Assessment of proposed road design at
the intersection of Yan Yean Road and
Bridge Inn Road, Doreen

Root Investigation Report

Prepared For: WSP

28 May 2019

Figure 4: Map of trees and areas that were trenched using NDRI

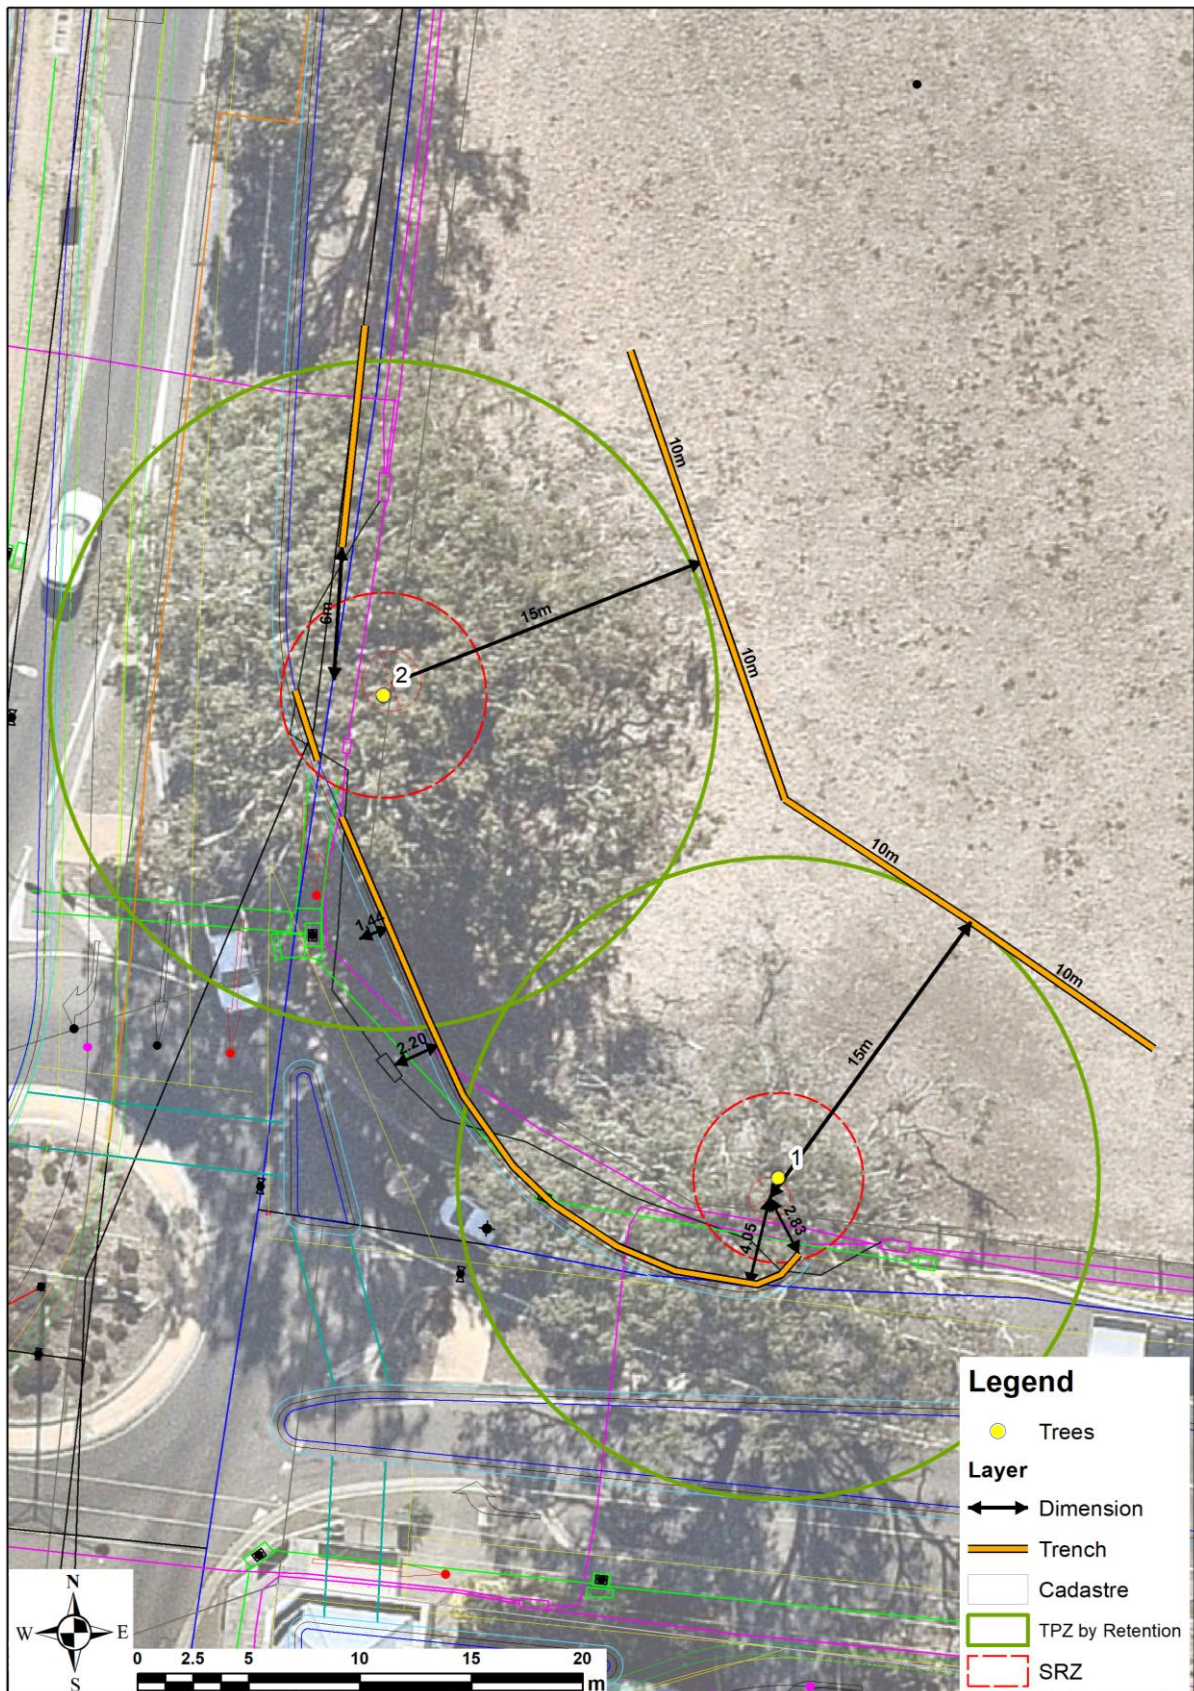
Trench 2 was a 40m section at a 15m offset to both trees in the paddock on the north-east side (Figure 4 and Figure 10). This location was chosen following discussion with Will Parker as the initial drawing supplied was found to be not to scale.

On the western and southern sides of the tree, where the design is proposed, provided excavation doesn't exceed approximately 800mm or get closer to the tree than investigated, there is unlikely to be any impact. In terms of the tree roots at depth, there will be little net change to the conditions above. This should maintain the trees as viable.

On the north-eastern side of the tree, works at an offset of 15m are unlikely to impact tree roots. Longer term issues may arise with a change to hydrology patterns as the trenched alignment is uphill of a small catchment. This will need to be taken into account if a design proceeds in this area, ensuring access to water long-term.

1. The design is refined to show required excavation and finished levels. The excavation for the road base should not exceed 600-800mm without additional investigation. There is to be no additional fill placed within the undisturbed areas of the TPZs.

2. If the design is shifted to the north-east, consideration is given to how the hydrology can be maintained within the small catchment to ensure the trees continue to receive water long-term.

5. There is to be no trenching behind the proposed alignment for utilities. Any conduits or pipes required within the TPZ are to be bored maintaining a minimum of 1m cover to natural ground.
